CITY OF AUSTIN – DEVELOPMENT SERVICES DEPARTMENT
SITE PLAN APPLICATION – MASTER COMMENT REPORT

CASE NUMBER: SPC-2016-0368A
REVISION #: 00
CASE MANAGER: Nikki Hoelter
UPDATE: U3
PHONE #: 512-974-2863

PROJECT NAME: Didactia Preschool
LOCATION: 1507 HETHER ST W/BLDGS

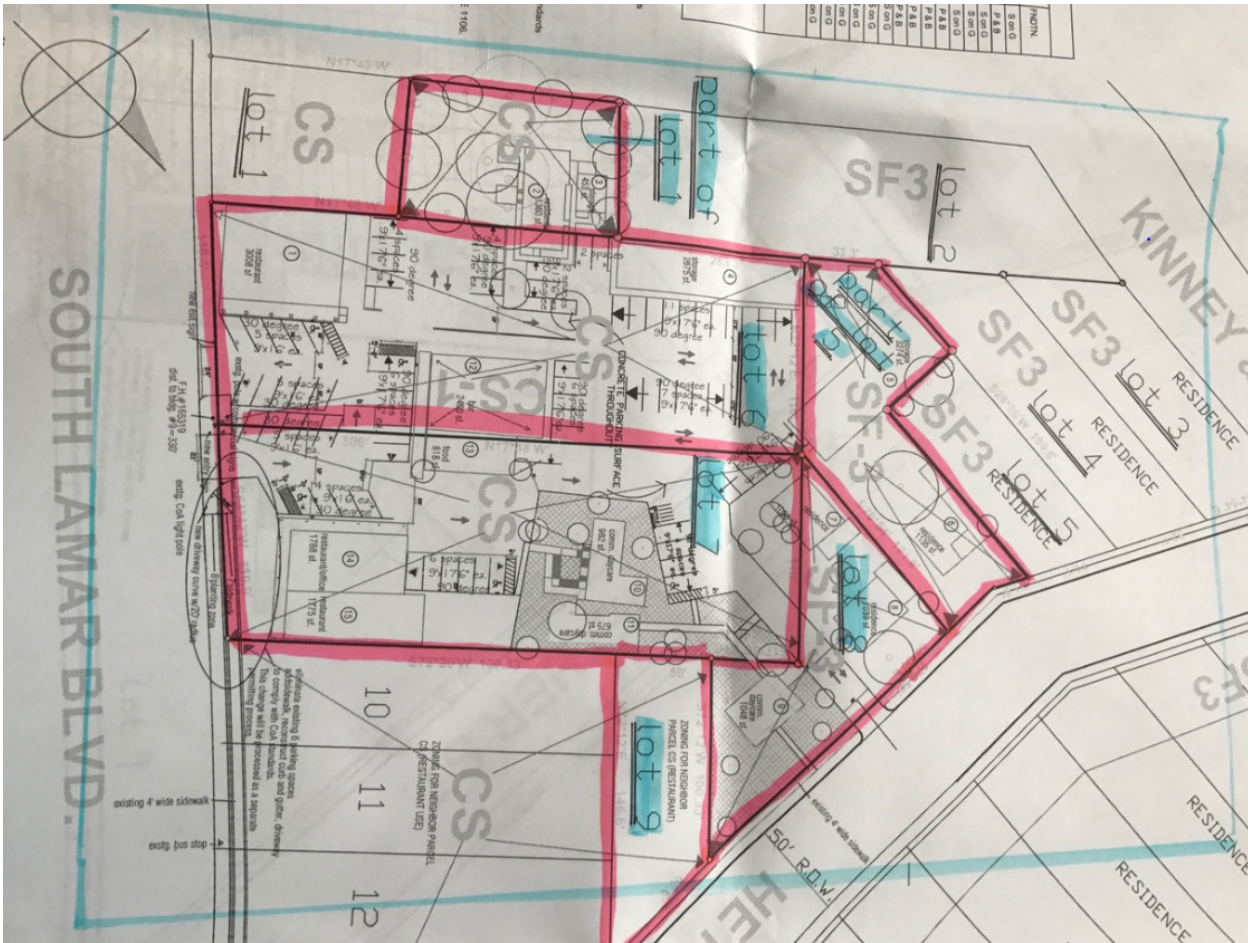
- SP 7. If the development is on more than one lot a Restrictive Covenant regarding Unified Development may be required to be executed. The document allows the development to encroach onto adjacent lots for the purpose of impervious cover, building coverage, joint access and parking.
Up# 1 – Comment not cleared, provide a clean copy of the document, which doesn't show an existing document number or information from another project. The document should be provided in a legible format, with an exhibit showing and labeling all lots being tied together with the document, as well as parking and joint access.
Up#2 – Comments specific to the legal document will be sent under separate cover, through email.

Up#3 –On the first sheet of the document under "Recitals", A should list the legal description as it's shown on the coversheet of the plan. How its currently shown is incorrect.

As shown in the screen shot, the exhibit should include the area within the blue highlighted area. The lots being tied together with document as highlighted in pink should be clearly shown on the exhibit.

(Highlight can be removed, only shown for clarification.)
